Service Bulletin

Bulletin No.: PIP5149A

Subject: P0324 Setting And/Or Poor Shifting Transmission During The 1-2 And 2-3 Shifts

Models: 2014 Chevrolet Silverado 1500
2014 GMC Sierra 1500
Built with RPOs 4.3L 5.3L L83 LV3

3608974

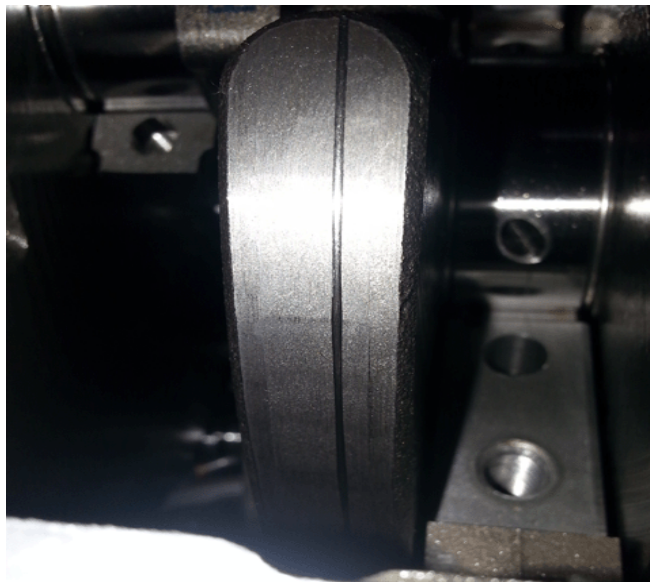
The dealer is authorized to remove the oil pan and inspect the oil squirters for contact.

If contact is noted the dealer needs to call PQC for a replacement engine. (PER PIP5114)
Pictures of normal crankshaft marking that are not caused by the oil squirter making contact.
